Salt Creek Ranch

Sectional Planning Area (SPA) Plan
Final Supplemental
Environmental Impact Report (EIR 91-03)

**SALT CREEK RANCH
SECTIONAL PLANNING AREA (SPA) PLAN
DRAFT SUPPLEMENTAL EIR 91-03
RESPONSE TO COMMENTS**

Site Plan for Final SPA Plan

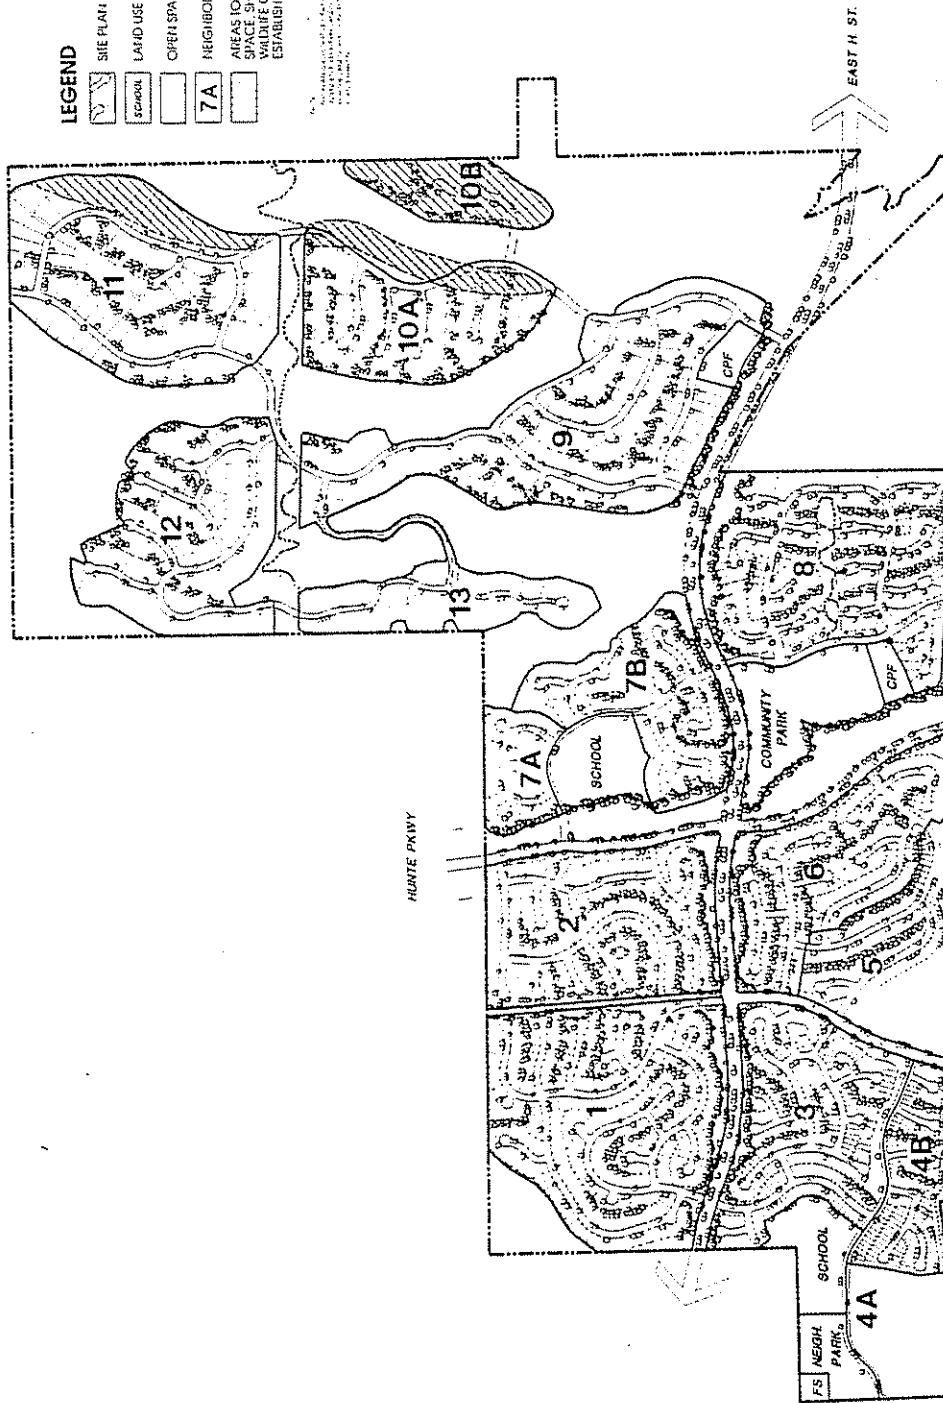
The project proposed to be implemented is the Final SPA Plan Design Alternative discussed in Section 5.3 of the Draft EIR text. Figure R-1 depicts the Final SPA Plan and Table R-1 provides a summary of proposed land uses. The Salt Creek Ranch design and final SPA document reflect numerous changes provided through extensive City involvement with the applicant and the applicant's consultants throughout preparation of the SPA Plan. Modifications included changes to the internal circulation system, ridgeline development design, and residential clustering. The modifications serve as mitigations; they do not create new issues or impacts over those issues analyzed for the proposed project discussed in Section 3 of the Draft EIR. The Final SPA Plan design is discussed below.
